DOCUMENT 00 90 10

ADDENDUM No. 3

- A. The Construction Contract is known as: *Mountain Green BNR Wastewater Treatment Plant*
- B. Date of this Addendum: 2/3/2023.
- C. All other provisions in the contract to remain in full force and effect.

HB POWER AND CONTROL PLAN

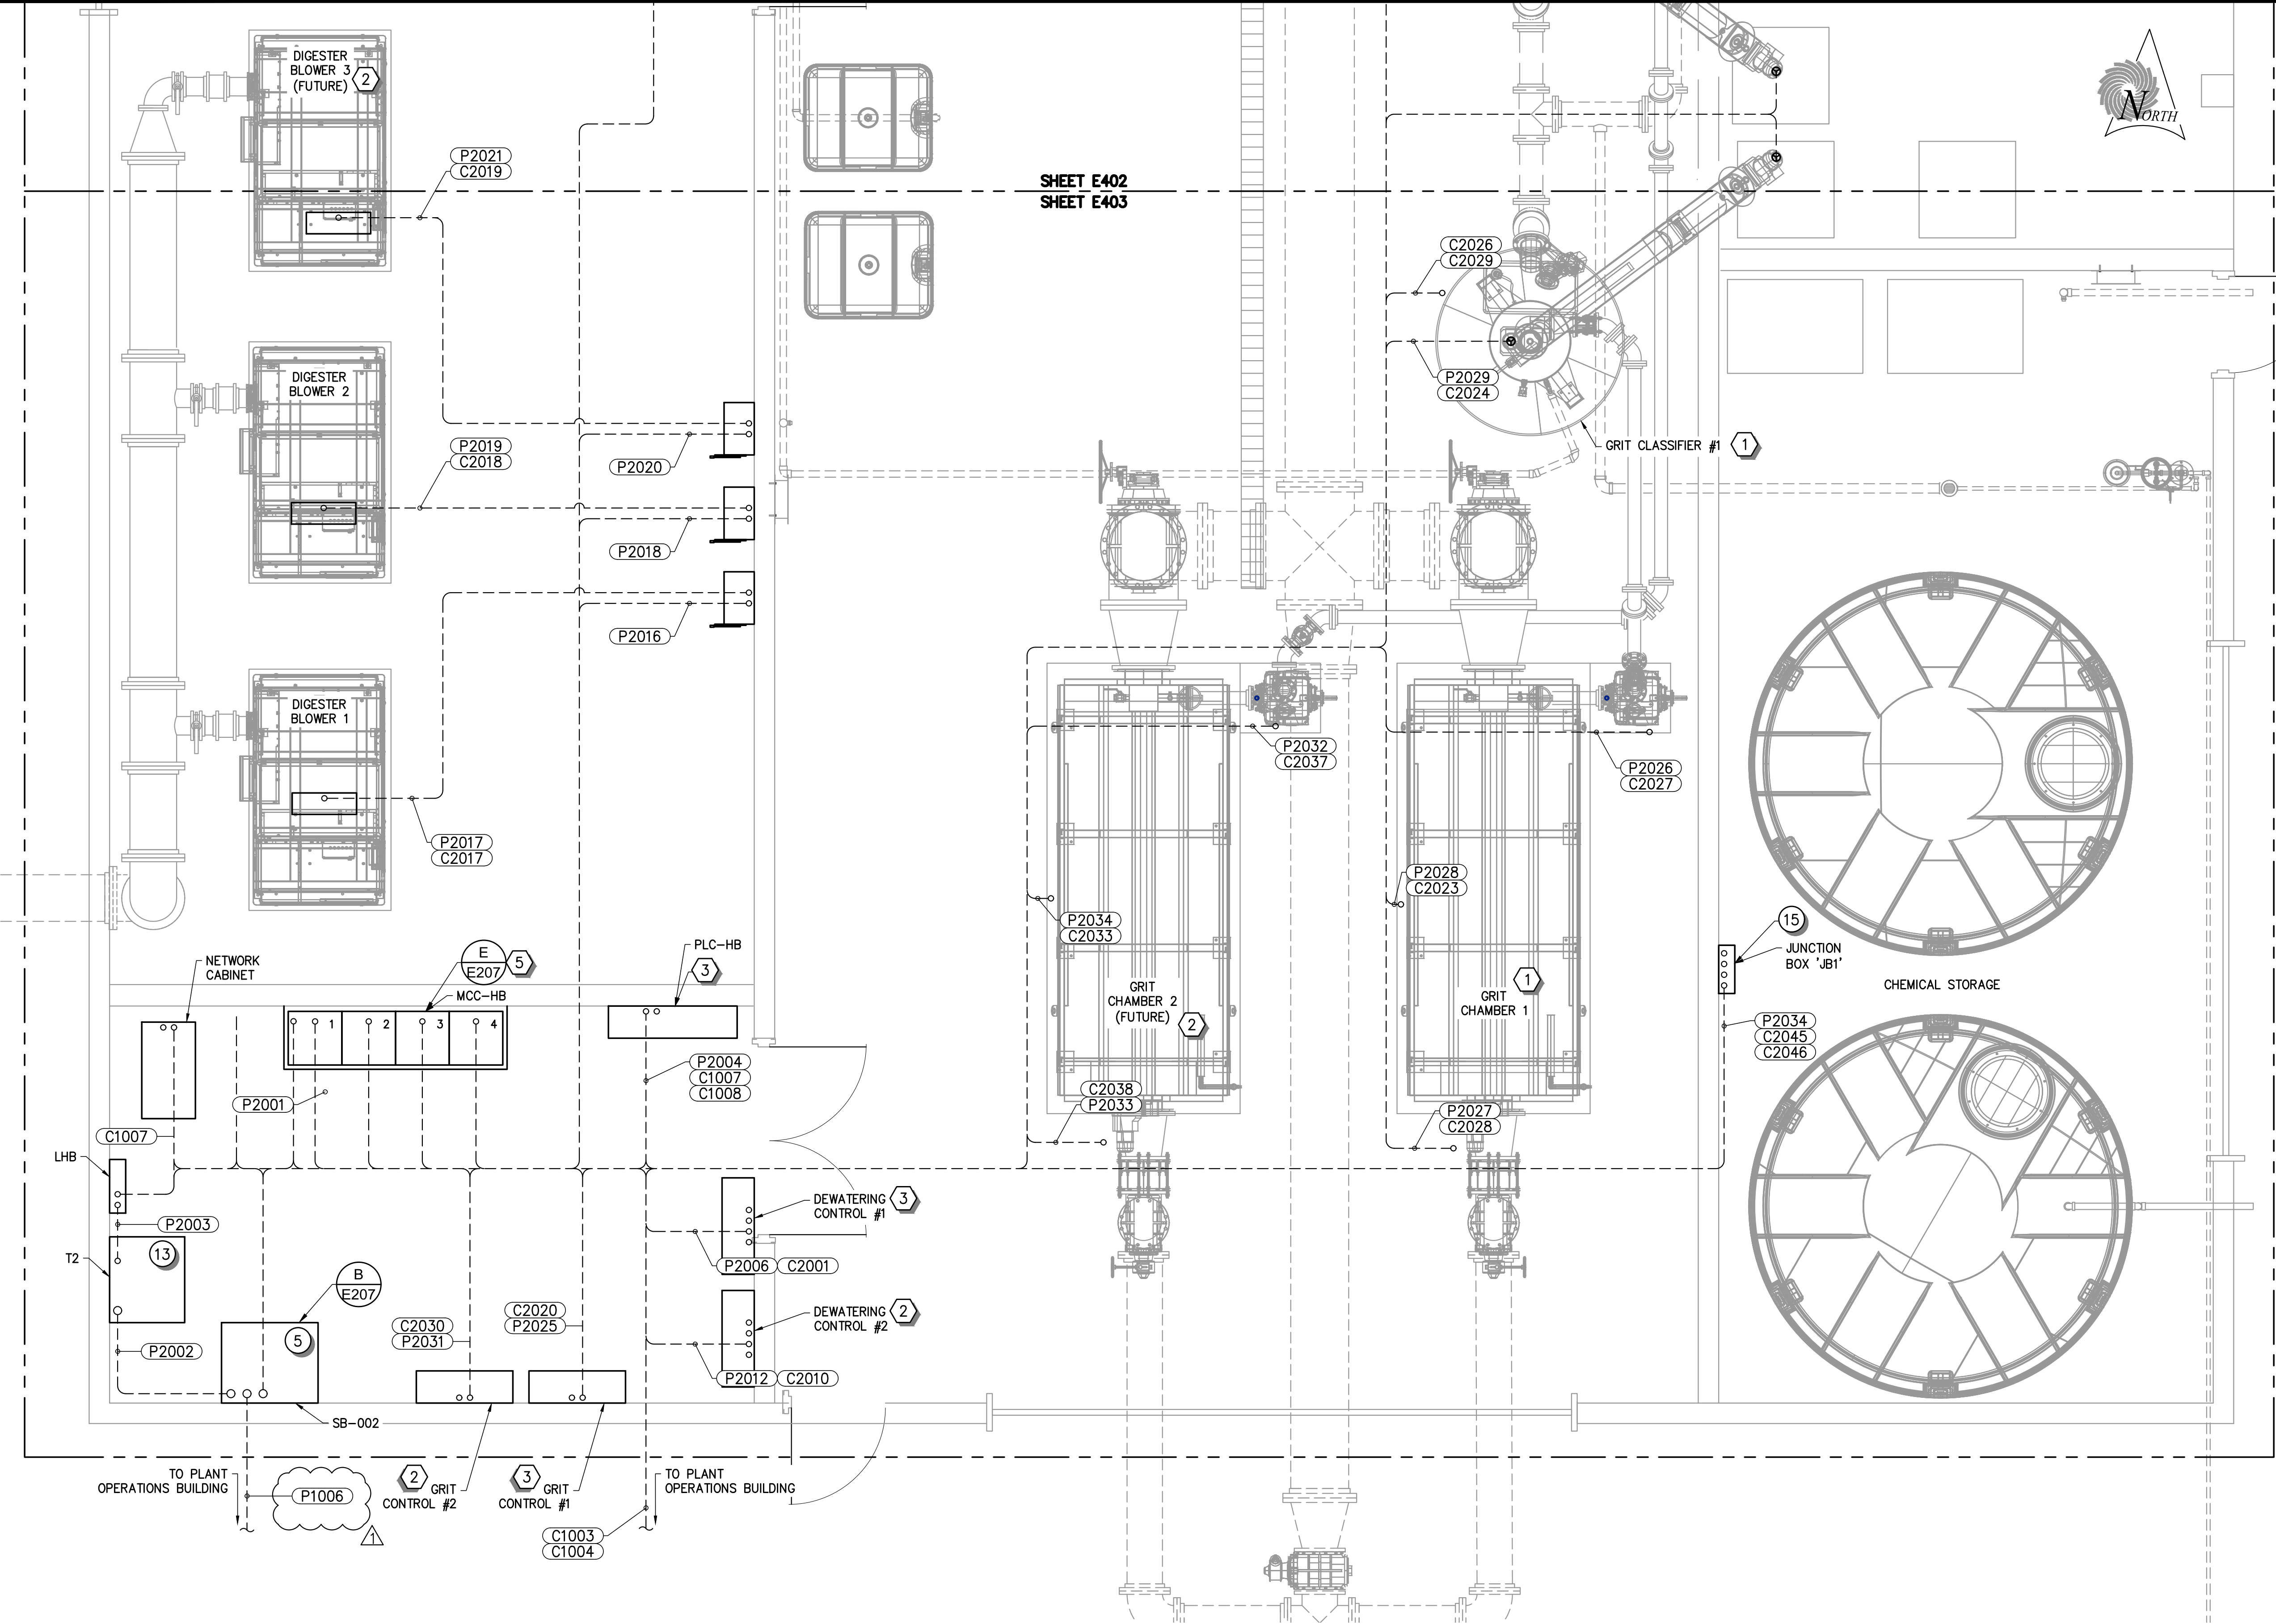
19) Question: Concerning drawing(s) E402 it shows local disconnects for three RAS pumps. However, on one line drawing E203 it does not show a disconnect. Do the RAS pumps require the local disconnect?

Response: The RAS Pump disconnect switches were deleted, but not removed from Sheet E402. The disconnects and conduits P2022A, P2023A and P2024A can be removed.
